**ZONING AND PLATTING COMMISSISON SITE PLAN  
CONDITIONAL USE PERMIT  
REVIEW SHEET**

**CASE NUMBER:** SPC-2013-0157C      **ZONING AND PLATTING COMMISSION  
HEARING DATE:** November 5, 2013

**PROJECT NAME:** Sams' Club # 6188-00

CITY OF AUSTIN – PLANNING AND DEVELOPMENT REVIEW DEPARTMENT  
SITE PLAN APPLICATION – MASTER COMMENT REPORT

OVERALL SITE PLAN

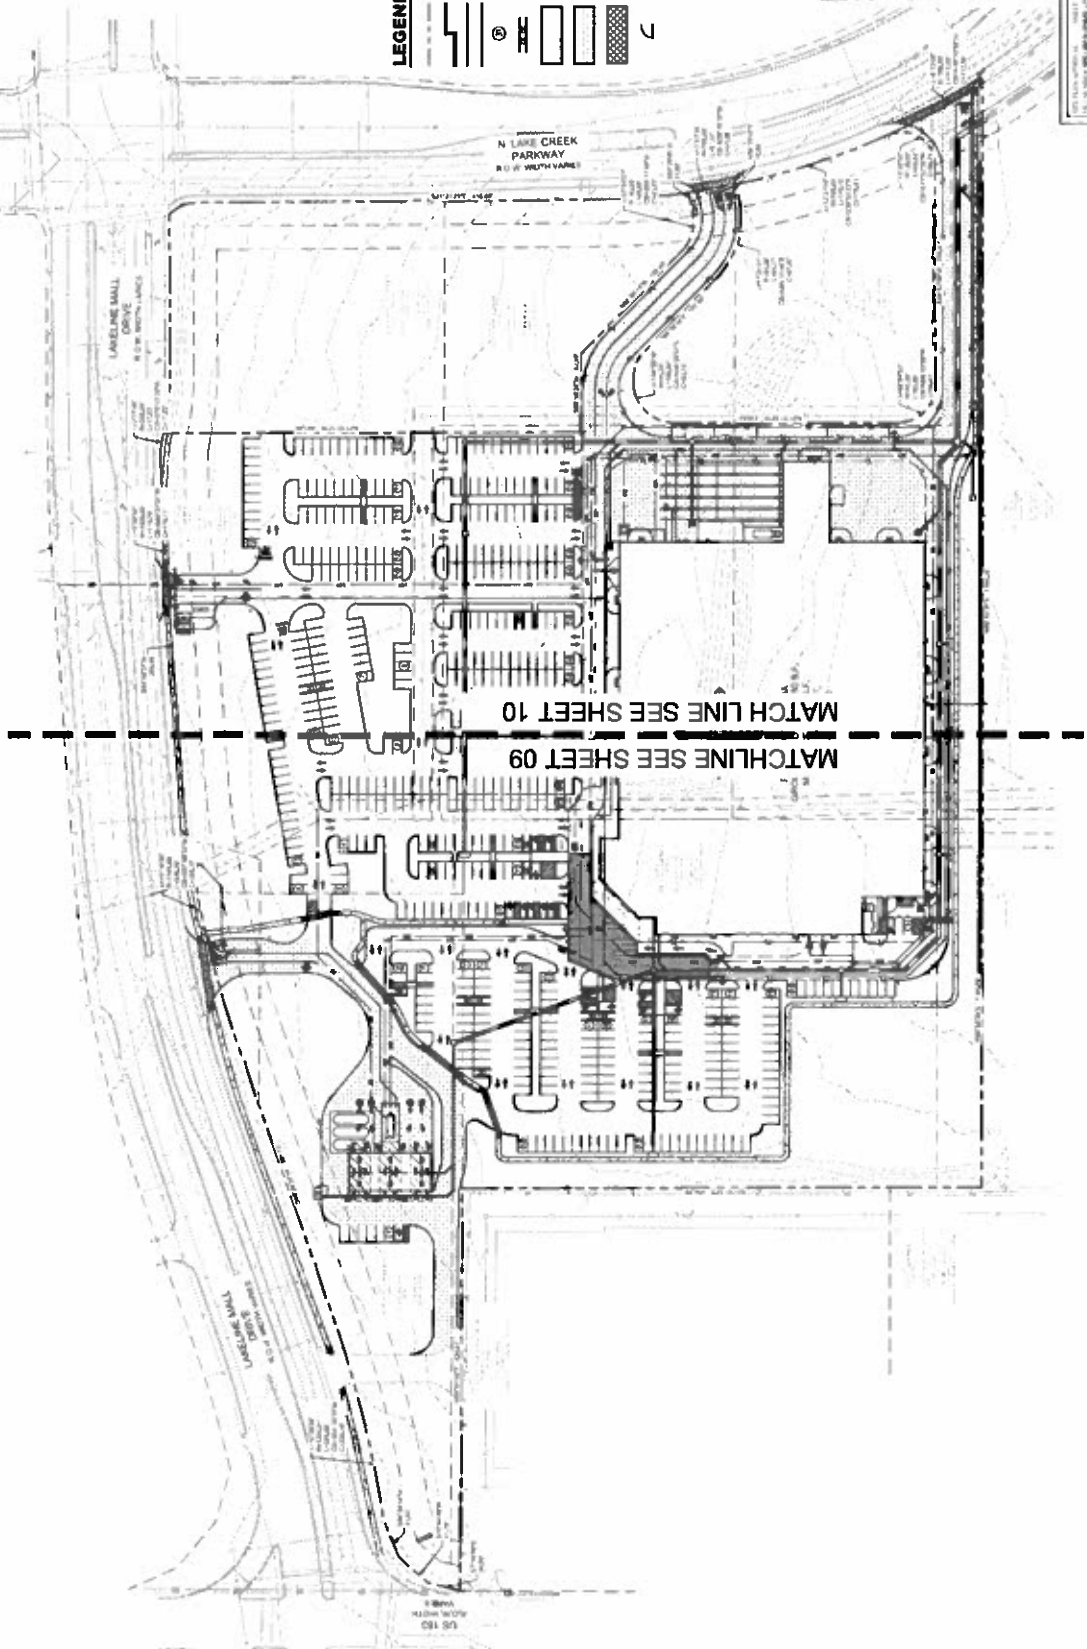
**4. For a large retail use described in Section 25-2-815 (Large Retail Uses) adversely affect the future redevelopment of the site:** This site is proposed in compliance with Subchapter E (Commercial Design Standards) Internal Circulation Routes and building placement. The design regulations for Internal Circulation Routes help ensure that future development can be accommodated easily, while maintaining pedestrian and vehicular circulation, and maintaining compliance with the intent of Subchapter E.
